Wulfsberg Electronics <i>A Chelton Group Company</i>			
APPROVALS		DATE		TITLE: SERVICE BULLETIN WSB IDU-III-8 (NAVIGATION DATABASE ERROR)	
DRAWN Robert DuRall		11/18/2003			
CHECKED Dean Boston		11/18/2003			
PRODUCT MANAGER Mark McCormack		11/18/2003			
ENGINEER		SIZE	CAGE CODE	DWG NO.	REV
ISSUED Vern Wallace		A	1B7G3	150-045972	A
Typed signatures indicate approval. Handwritten signature approval of this document is on file at Wulfsberg Electronics, Prescott, Arizona.		SCALE: NONE		DO NOT SCALE DRAWING

SERVICE BULLETIN

EQUIPMENT: IDU-III

BULLETIN NUMBER: WSB IDU-III-8 Revision A

RNAV (GPS) V RWY 8 JUNEAU INTL (JNU)

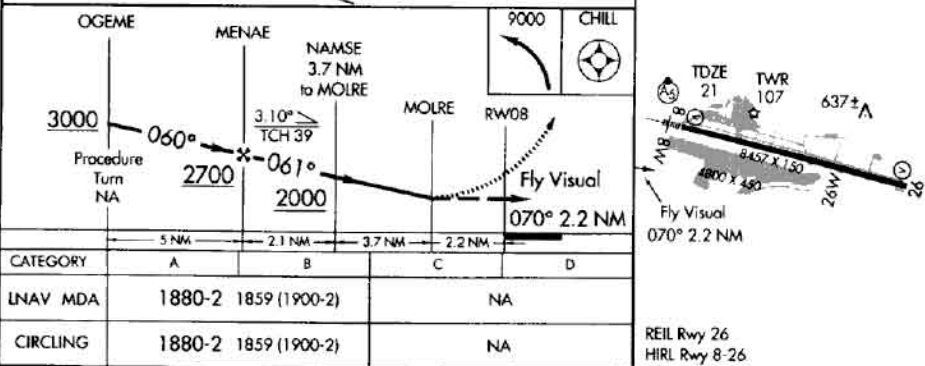
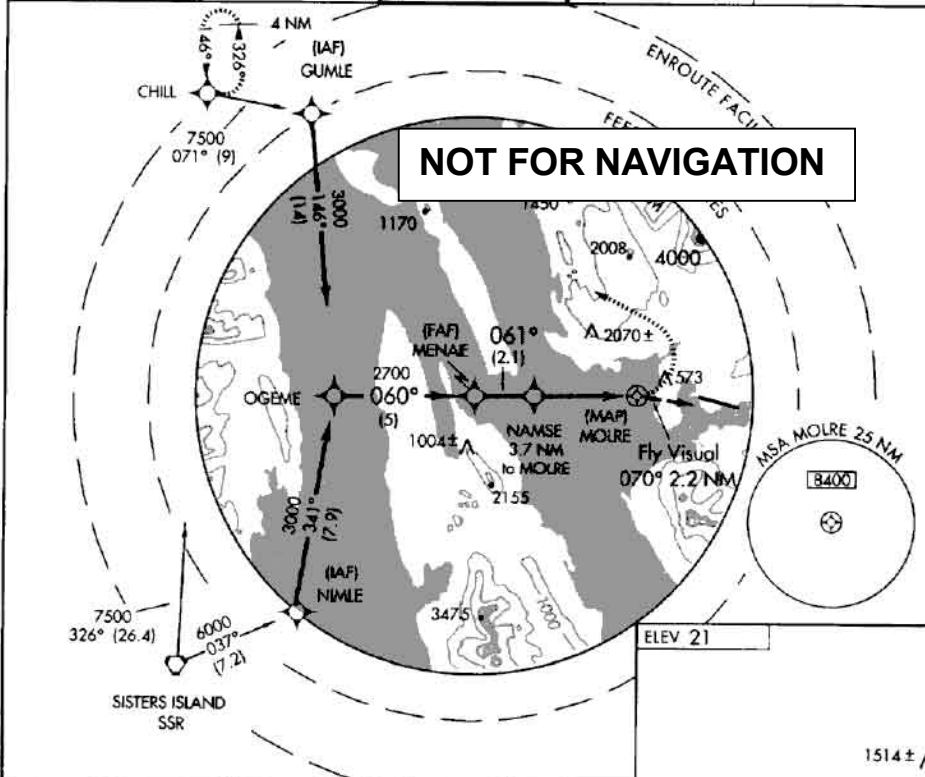
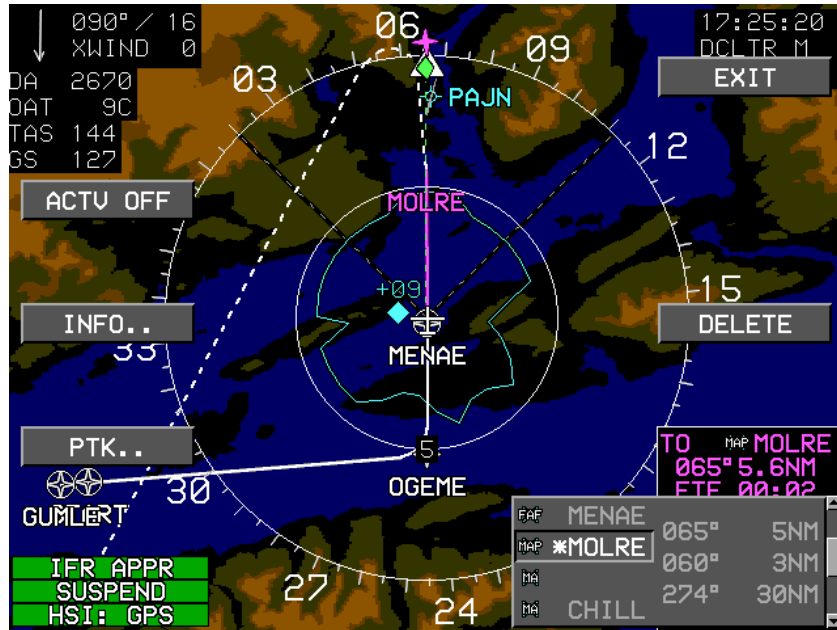
The government source coding (Form 8260-3) for this approach included an erroneous climb to altitude leg as the first leg of the missed approach procedure. This error was propagated from the government source through Jeppesen and Chelton and into the

field as part of the cycle 0311 navdata. In accordance with its DO-200A process, Chelton has corrected the error with notification to and concurrence from Jeppesen. The corrected navdata complies with ARINC424-16 Attachment 5 Rule 9.4 and is now available for use from Chelton's website.
